TRANS/WP.29/GRPE/2003/17  
24 March 2003

World Forum for Harmonization of Vehicle Regulations (WP.29)

PROPOSAL FOR DRAFT AMENDMENTS TO REGULATION No. 83  
(Emissions of M1 and N1 categories of vehicles)

Transmitted by the experts from the European Commission (EC)

"Figure 4/1:  
In-service conformity checking – audit procedure

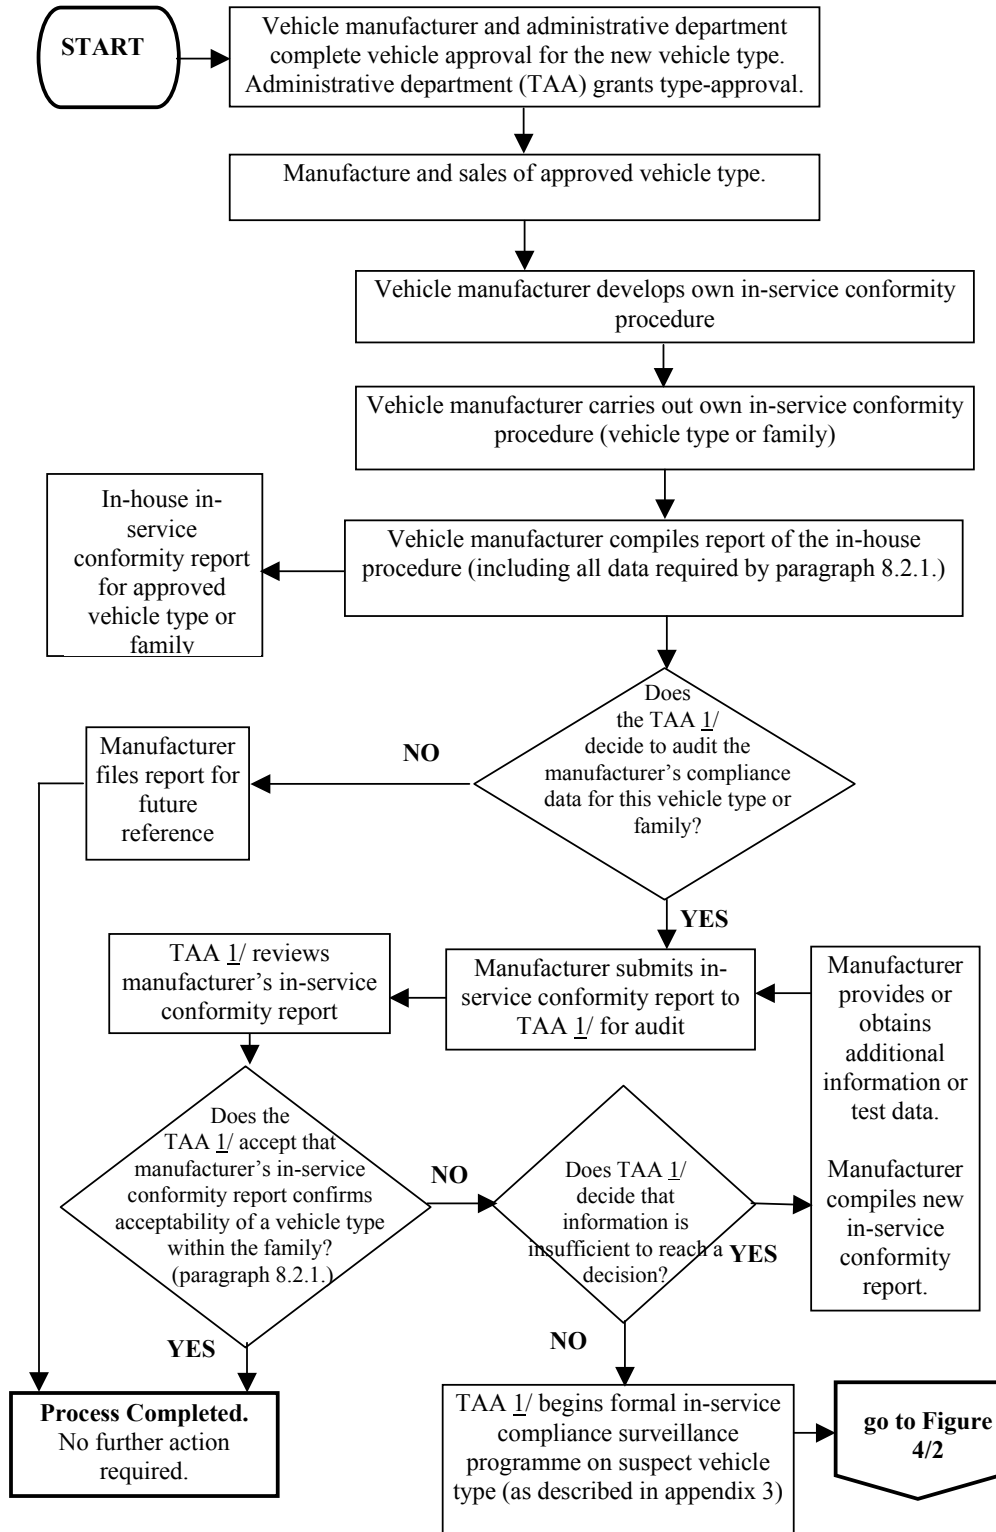
Insert a new Figure 4/1, to read (see next page).

"Figure 4/2:

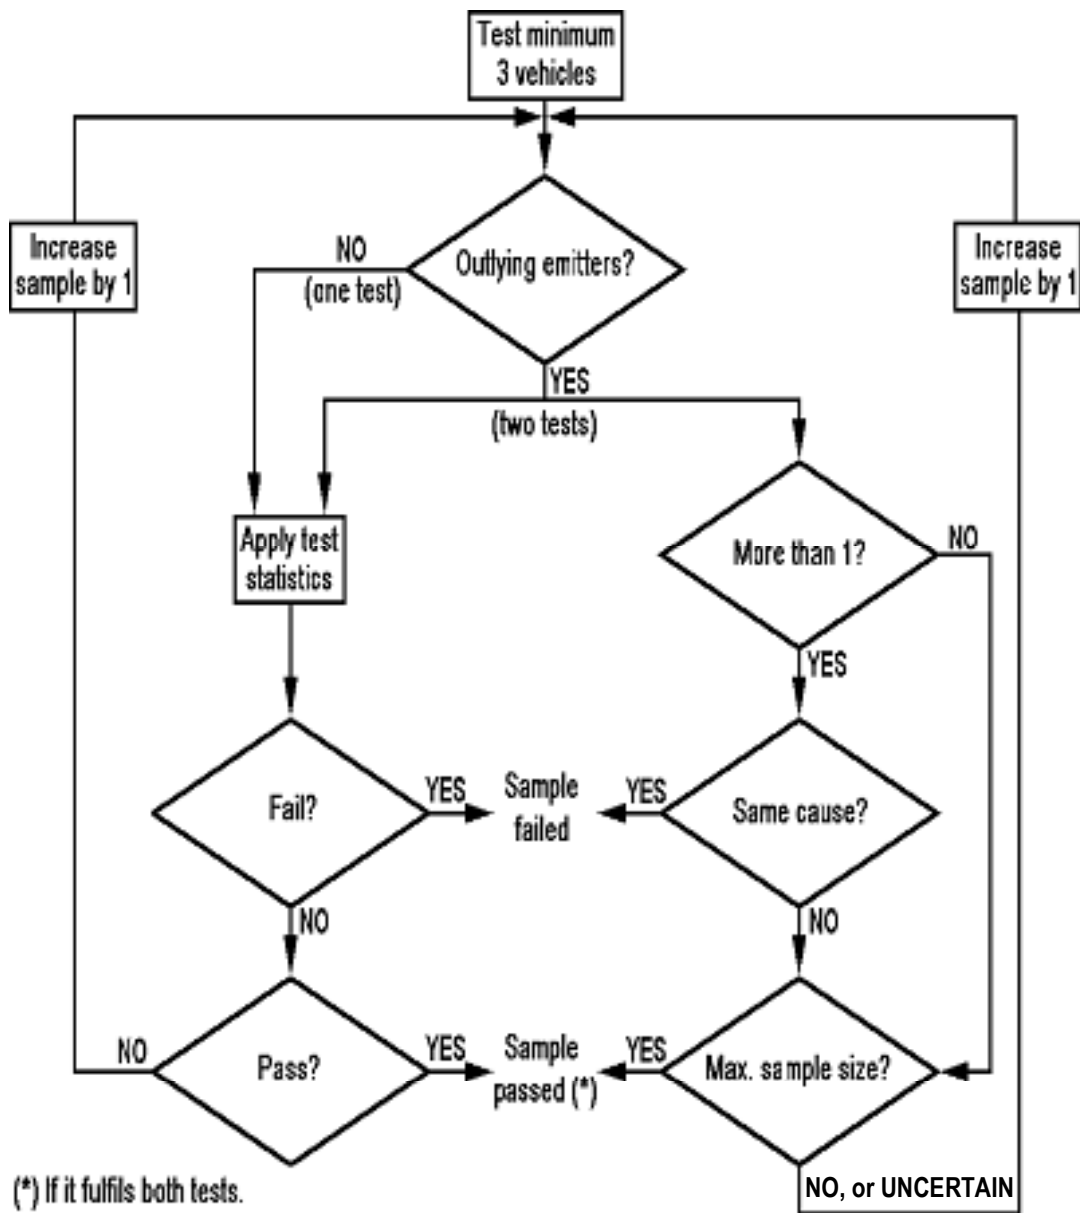
Figure 4/1 (former), rename as Figure 4/2 and amend to read:
